RE: DA2020/0347 – New Seniors Housing Units with Basement Parking Development Application at 49 Forest Way, FRENCHS FOREST NSW 2086

As neighbours to the proposed development at 49 Forest Way, we wish to submit to the local planning panel these specific concerns in relation to the proposed development:-

Outlook from our living area showing trees 1, 2 and 3 and the beautiful autumn leaves and shade they provide our front yard and the street.

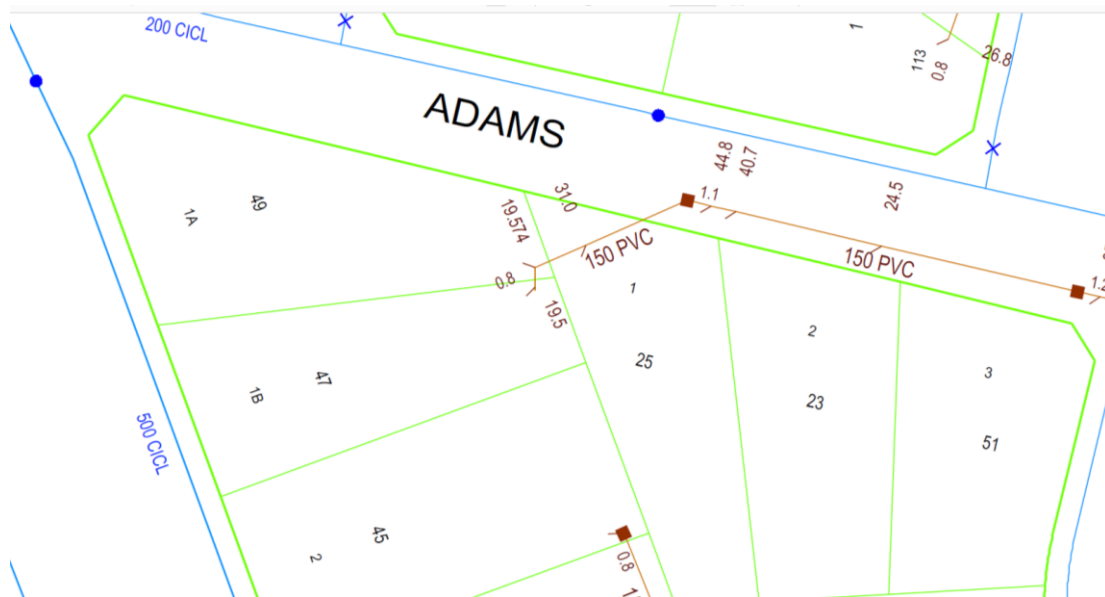
The proposal will result in the loss of significant trees, and specifically the loss of trees 1 and 2 is detrimental to our amenity. These Liquid Amber street trees are an important characteristic of Adams Street and provide much appreciated shade to our front yard through the warmer summer months as well as a leafy outlook from our living areas and bedroom window. The arborist report indicates that these trees have A1 retention value. As noted earlier the position of the driveway will mean loss of two beautiful trees, and the noise and headlights of cars coming straight into our master bedroom and living area. SEPP 2004 Clause 33, Chapter 3 Part 3 Division 2 states **(f) retain, wherever reasonable, major existing trees.**

Trees 1 and 2 provide considerable visual amenity to Adams Street. Both trees listed with A1 retention value in arborist report. Proposed driveway relocation would enable tree 1 to be retained which is well within our side of the prolonged boundary through road reserve.

We request the planning panel require a relocation of the driveway to at a minimum enable retention of tree 1.
